Re: Crown-Indigenous Relations and Northern Affairs Canada (CIRNAC) technical review comments for water licence amendments of 2AM-MEA1526, 2AM-WTP1826, and 2BB-MEA1828 – Whale Tail Expansion project.

Summary of Technical Review Comments

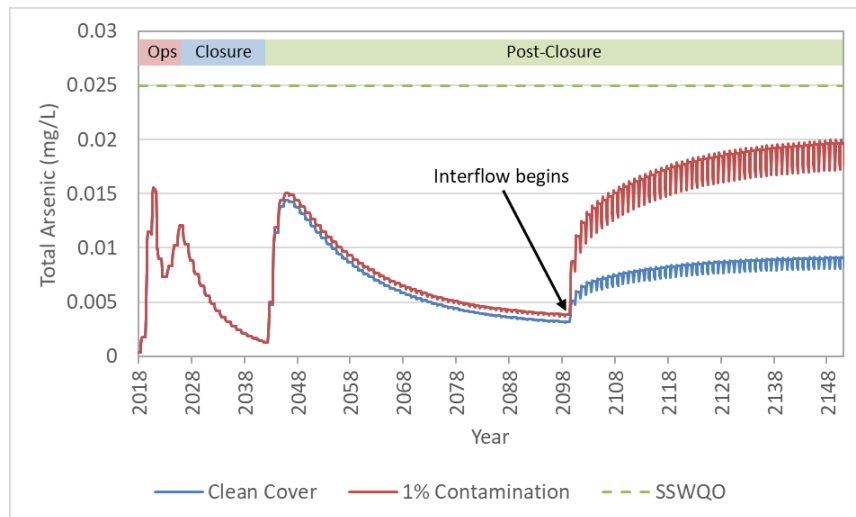
Review Comment	<p>CIRNAC IR #3 requested the following:</p> <p><i>CIRNAC recommends that AEM extend the temporal scope of its water quality modelling to ensure that WRSF interflow is included in its predictions of surface water quality. The revised modelling should evaluate the water quality impacts of interflow under two scenarios:</i></p> <p><i>Scenario 1: a cover constructed exclusively of waste rock with low metal leaching potential; and</i></p> <p><i>Scenario 2: a cover that is “contaminated” with 1% waste rock that has elevated metal leaching potential (e.g., north komatiite formation)</i></p> <p>AEM’s response to CIRNAC IR #3 provided the requested information. The response included the following figure which summarizes average arsenic concentrations within Mammoth Lake over time:</p>

Using this figure and other information in AEM's licensing submission, CIRNAC has made the following observations:

- 1) AEM predicts that seepage from interflow will begin approximately 80 years following the development of the WRSFs. The interflow "breakthrough" results in a marked increase of arsenic concentrations in Mammoth Lake.

- 2) The limited temporal scope indicates the seepage of the WRSF would be negligible. Extending the modelling to include the interflow breakthrough demonstrates more significant seepage.

- 3) The modelling was performed using less-conservative assumptions when compared to previous modelling presented by AEM (e.g. during the NIRB process). The reduced conservatism should be considered when evaluating the revised modelling results.

- 4) Despite the increase in arsenic concentrations that is predicted to occur around the year 2100, the concentrations for a "clean" cover are predicted to remain well below the applicable Site-Specific Water Quality Objective (SSWQO) of 25 ug/L. However, the concentrations will be significantly elevated relative to baseline for an extended period (i.e. more than a hundred years after closure).

- 5) For a cover that contains 1% rock with elevated arsenic leaching potential, concentrations are predicted to stabilize at approximately 20 ug/L (i.e. 80 % of the SSWQO). Given the uncertainty inherent in such predictions, as well as the reduced conservatism used in the assessment, the potential for
